PROTEST- PETITION
This form may also be used for objections

PETITION FOR TIME EXTENSION, CHANGE, TEMPORARY URGENT CHANGE

Protest of the California Department of Water Resources' and U.S. Department of the Interior, Bureau of Reclamation's Petition for Change in Points of Diversion and Rediversion of Certain Permits within the Sacramento/San Joaquin Delta Estuary

RE: Solano County Comments on the Draft Bay Delta Conservation Plan (BDCP) / California WaterFix (CA WaterFix) Partially Recirculated Draft Environmental Impact Report and Supplemental Draft Environmental Impact Statement (RDEIR/SDEIS)

Figure 1: Daily EC values at Barker Slough from the sensitivity analyses for the period October 1976 through September 1984.

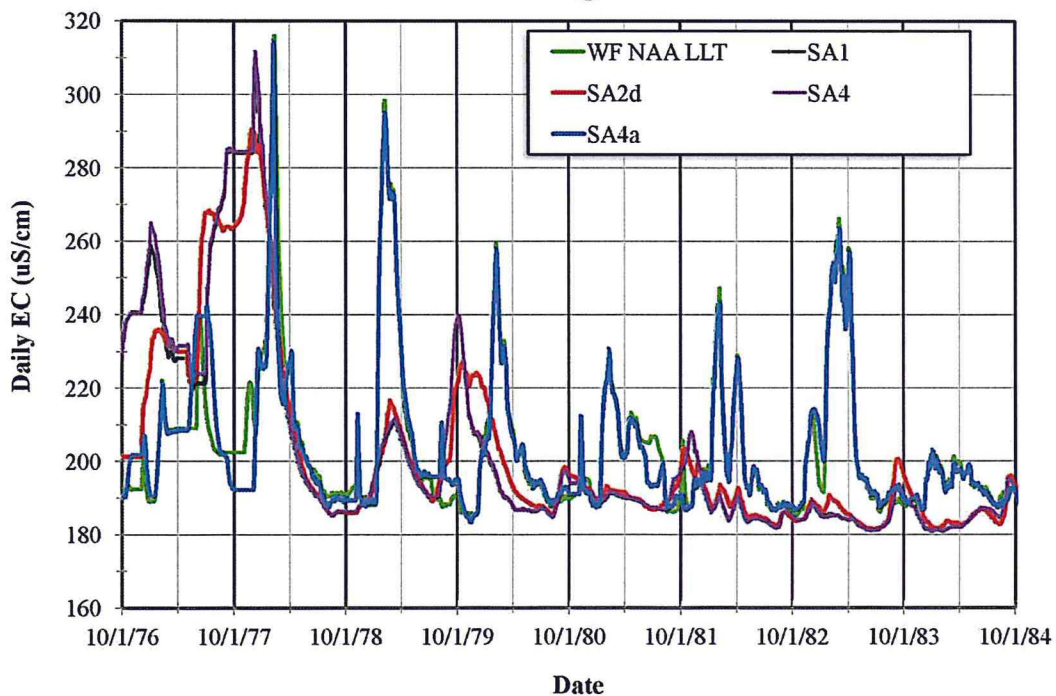
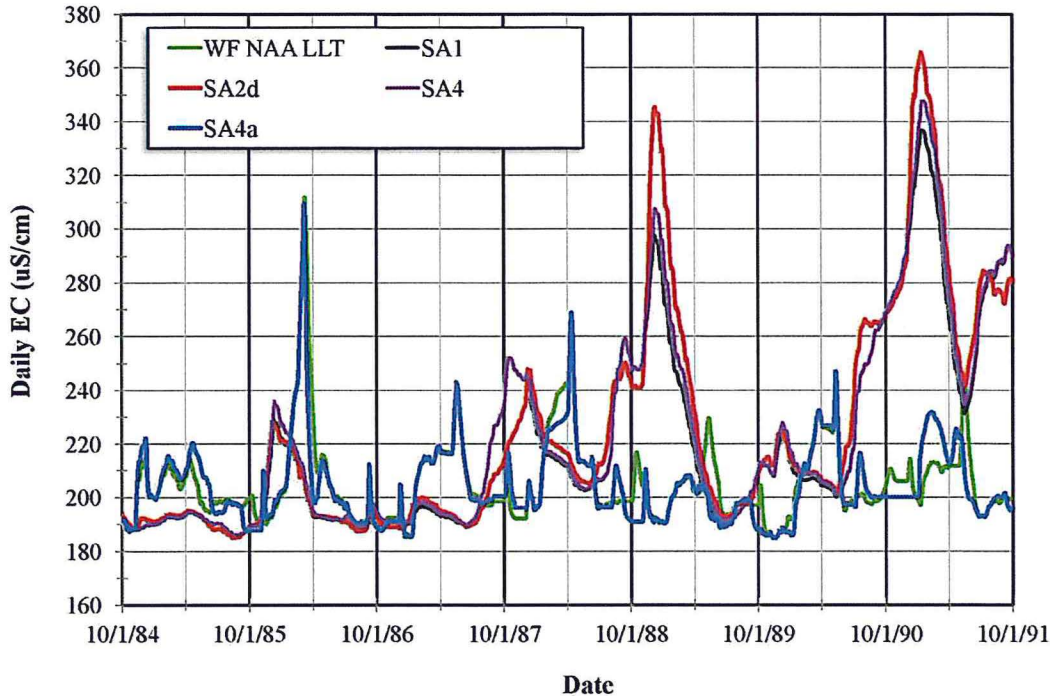
The Sensitivity Analyses were based on the flawed modeling for Alternative 4, Scenario H3 at late long term, i.e., 2060 conditions with habitat restoration (which is no longer included with new Alternative 4A), and not updated using the most recent versions of the CALSIMII and DSM2 models. The following two figures show the range of EC at Barker Slough for the following sensitivity analyses used by DWR:

Also plotted for comparison purposes is the No Action Alternative developed for the WaterFix RDEIR/SDEIS for late long term. The WaterFix RDEIR/SDEIS only presented the water quality data as the averages for each month of the year for the short period modeled, water years 1976-1991, and for the water year 1987-1991 drought period. The 1976-1977 drought period was not included in the drought averaging.

corresponding presentation of EC data (Table EC-8A) does not show the averages for Barker Slough or Belden's Landing. This is a significant omission.

Figure 3: Scatter plot of daily EC values at Barker Slough from the WaterFix sensitivity analyses with no restoration (SA4a, LLT) for the period October 1975 through September 1991. Some peak EC are reduced relative to the No Action equivalent but significant adverse impacts occur at other times.

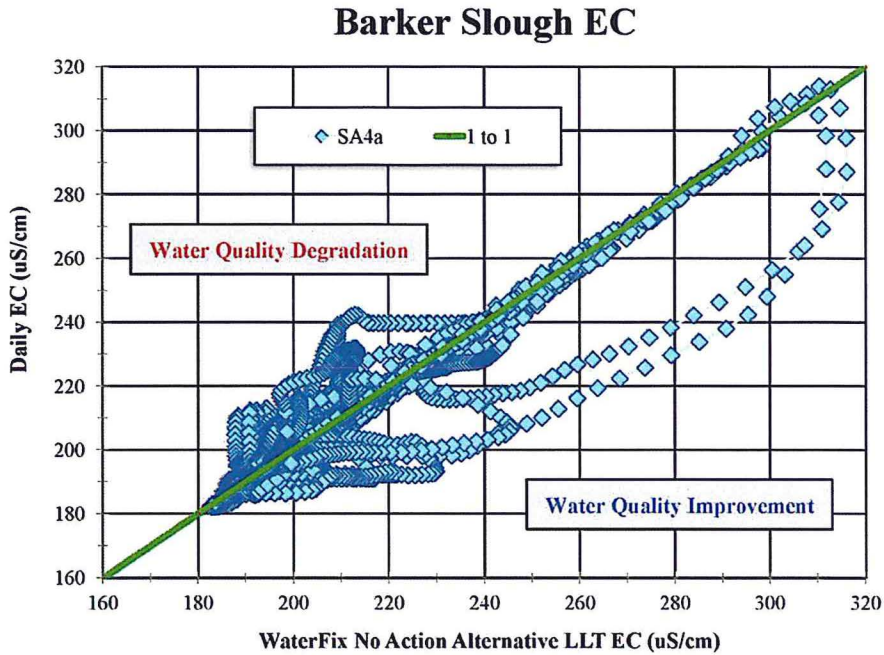
The following figures (Figures 3 and 4) show the EC data for each month of the 16-year sensitivity analysis simulation period (192 data points) in the form of scatter plots. The EC data for Barker Slough and Belden's Landing for Sensitivity Analysis #4 (no habitat restoration) are plotted as a function of the WaterFix No Action Alternative. Both are at late long term.

Some peak ECs at Barker Slough are reduced relative to the No Action equivalent but significant adverse impacts occur at other times. There are some reductions in EC relative to the No Action equivalent at Belden's Landing but significant adverse impacts occur at other times. The presentation of water quality data must present the data in sufficient detail to fully disclose the daily or month to month variations in water quality, in particular the occasions when salinities increase significantly. It is not acceptable to only present long-term averages that obscure and reduce the significant impacts on urban and agricultural water users, and the Delta ecosystem.

The WaterFix RDEIR/SDEIS is inadequate because it fails to present analysis data in a form that discloses the daily or month to month impacts of the proposed project on water quality and fails to avoid or provide definitive mitigation for these significant impacts on water quality.

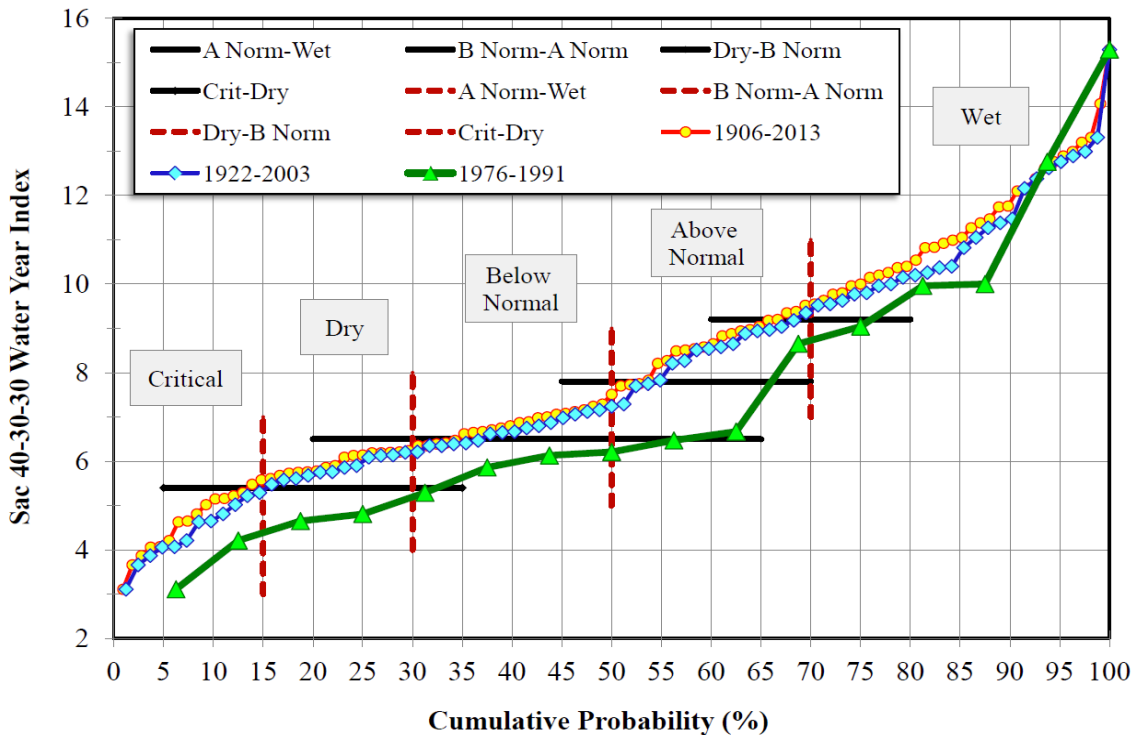
The analysis of water quality impacts in the DEIR/EIS is also flawed because the decision to disaggregate only some of the monthly CALSIM II flow output into daily flows prior to input into the DSM2 model. (DEIR/EIS pp. 5A-A15 & 5A-A40). The Sacramento inflows are input as daily data but the exports are still monthly-averages, which implies an equal export quantity for each day of a given month. In months where a storm occurs late in the month, this disaggregation process can create unrealistic negative daily flows at the beginning of the month and cause unrealistically large spikes in salinity that often exceed D-6141 standards. The BDCP water quality modeling must be revised using either all daily data as inputs, which is the preferable method, or all monthly data.

The daily specific conductance (EC) data for the No Project Alternative in early November 1981 at Jersey Point and Rock Slough is a good example of this flaw, where the EC at Rock Slough spikes up to 1,800 $\mu\text{S}/\text{cm}$, equivalent to a chloride concentration of 460 mg/L. This is well in excess of the SWRCB 250 mg/L standard. These errors in the predictive calculations render any comparisons between the baseline and the proposed project or to the project alternatives invalid. This also distorts the potential impacts on water quality, Delta water users, and fish.

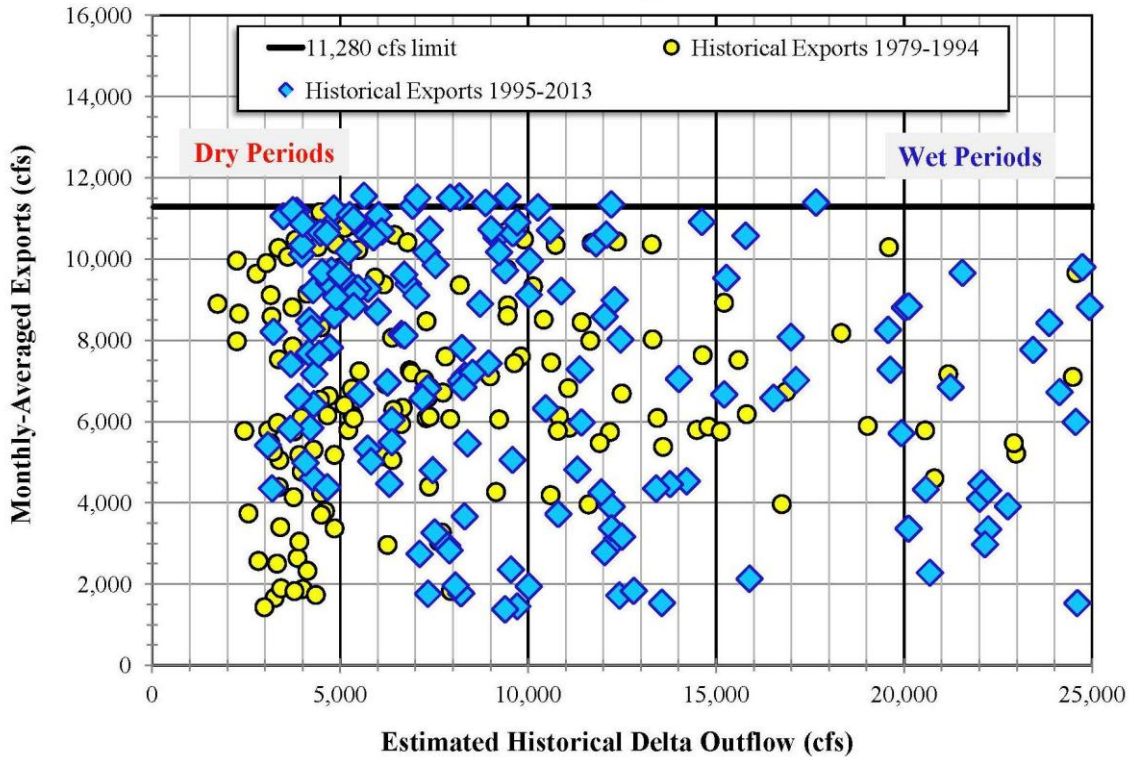
Figure A-1 shows the historical Delta exports as a function of Delta Outflow for the years since the Bay-Delta Accord and SWRCB Water Rights Decision 1641, and the earlier period (1979-1994) after adoption of SWRCB Water Rights Decision 1485. D-1485 introduced minimum Delta outflow requirements and these were made even more stringent in D-1641. The south Delta exports are limited to 11,280 cfs with an extra 500 cfs allowed July-September. The additional allowance based on San Joaquin inflow to the Delta (December 15 – March 15) typically does not apply until Delta outflows are much higher than 25,000 cfs.

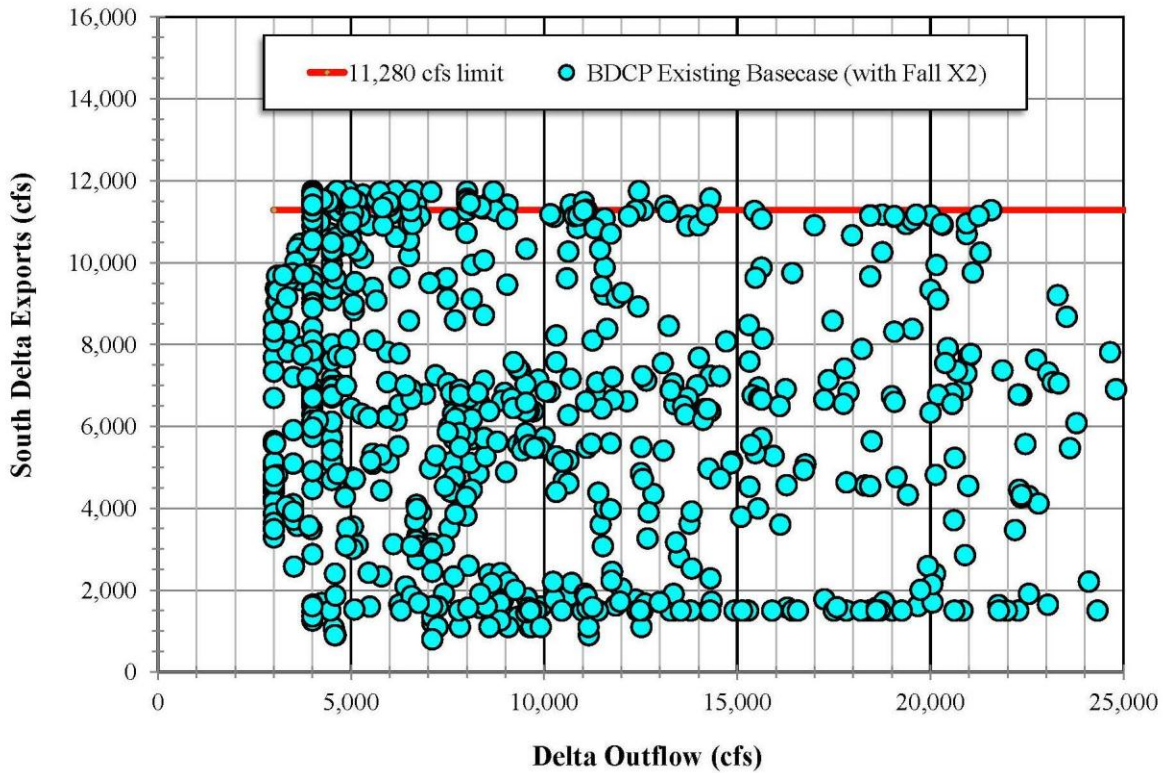
Figure A-2 shows the south Delta export data from an existing basecase simulation (with Fall X2) for the BDCP, also as a function of Delta outflow. This simulation was based on historical hydrology for water years 1922-2003. However, in this DWR planning study, the level of development and demands are the same for the whole 83-year period. Figure A-2 shows similar results as the historical data (Figure A-1).

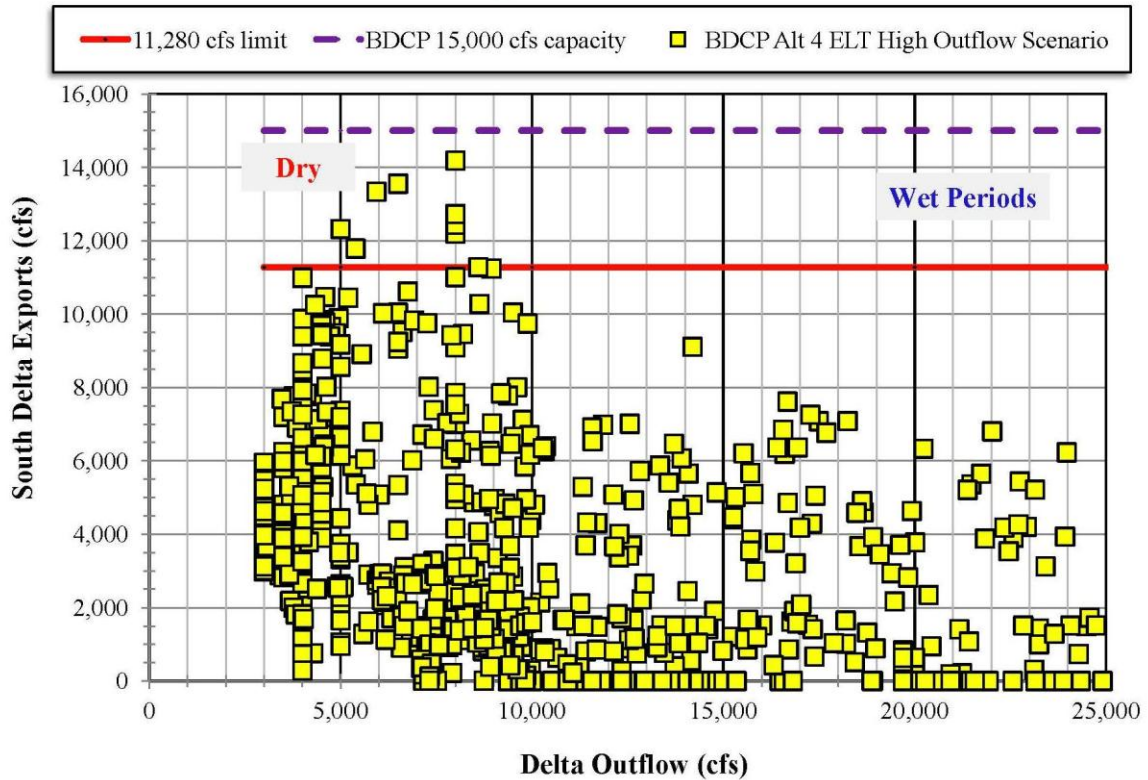
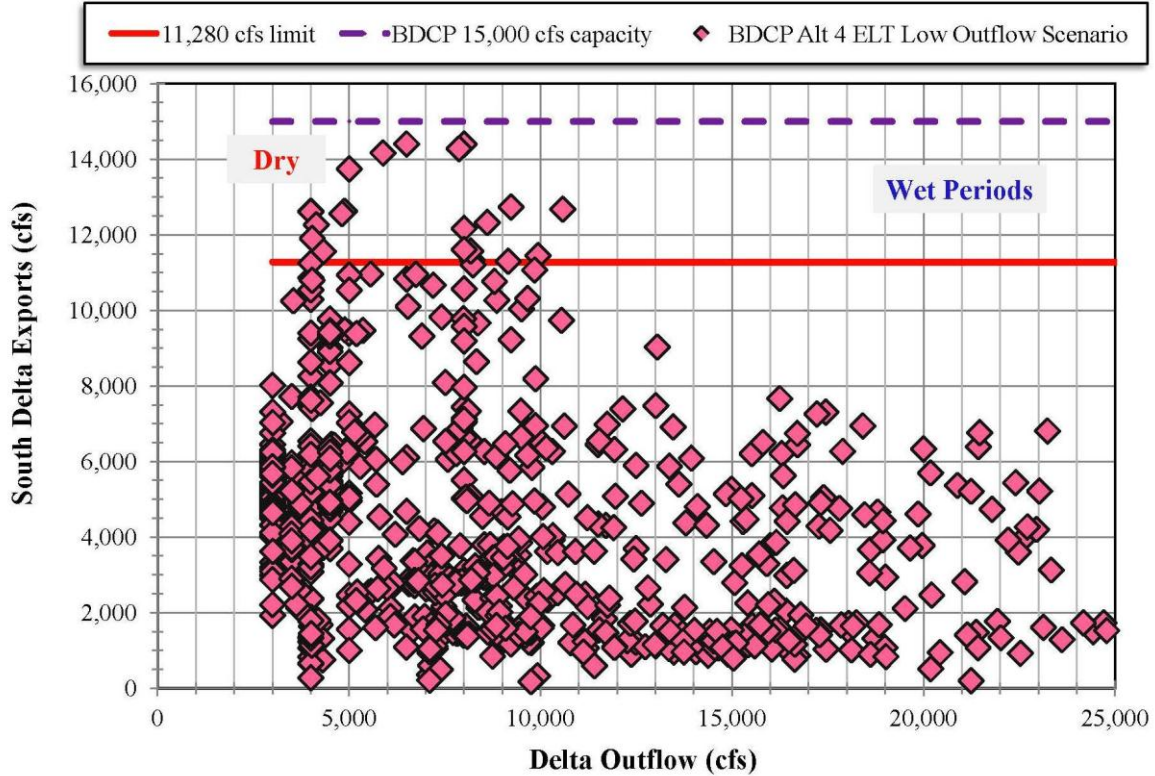
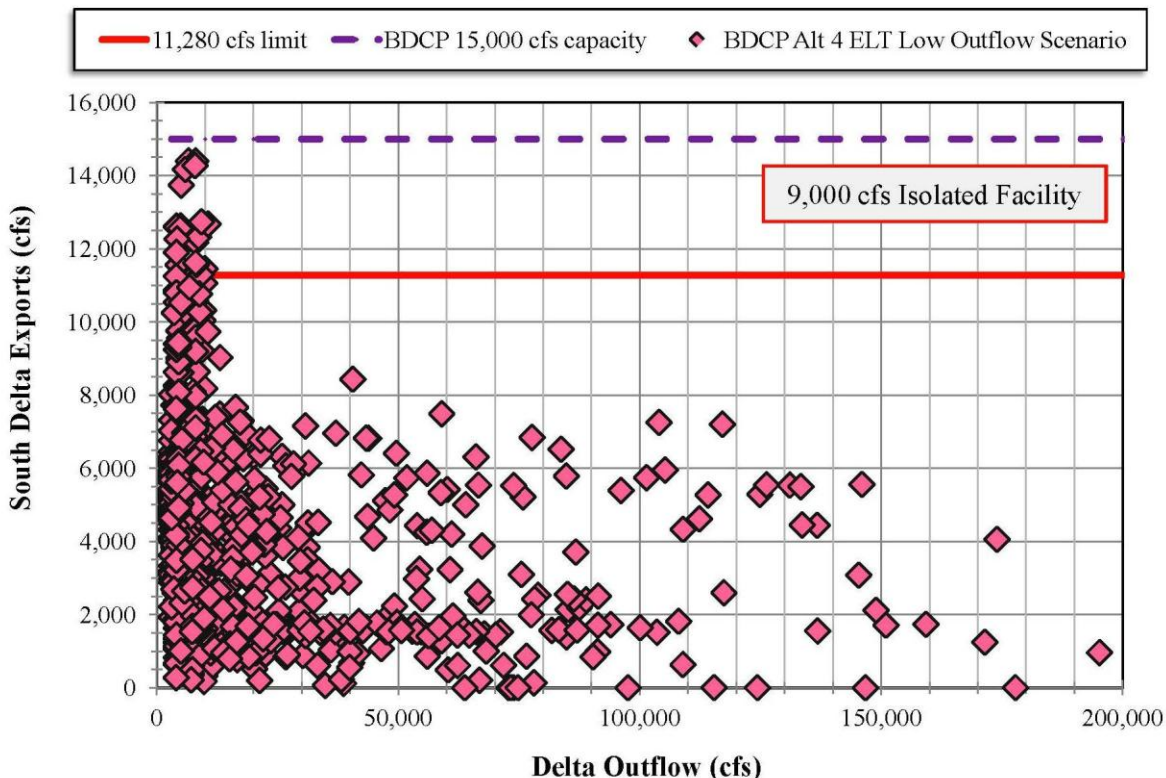
Figure A-3: South Delta exports as a function of Delta Outflow for BDCP Early Long Term Alternative 4 High Outflow Scenario for outflows up to 25,000 cfs. A goal of the BDCP is to improve ecosystem conditions in the south Delta by reducing exports from the south Delta. The BDCP proposed project may reduce south Delta exports in wetter months but significantly increases south Delta exports in a number of drier months when fish species are already stressed.

Figure A-4: South Delta exports as a function of Delta Outflow for BDCP Early Long Term Alternative 4 Low Outflow Scenario for outflows up to 25,000 cfs. A goal of the BDCP is to improve ecosystem conditions in the south Delta by reducing exports from the south Delta. The BDCP proposed project needs additional limits on exports because it significantly increases, rather than decreases south Delta exports in a number of months, and all those increases occur during the driest months when fish species are already stressed.

Figure A-5: South Delta exports as a function of Delta Outflow for BDCP Early Long Term Alternative 4 Low Outflow Scenario. This graph is the same as Figure A-4 but shows are larger range of Delta outflows (i.e., up to 200,000 cfs). A goal of the BDCP is to improve ecosystem conditions in the south Delta by reducing exports from the south Delta. The BDCP proposed project is inadequate and fails to meet the original BDCP goals because it significantly increases, rather than decreases, south Delta exports, and all those increase occur during the driest months when fish species are already stressed.
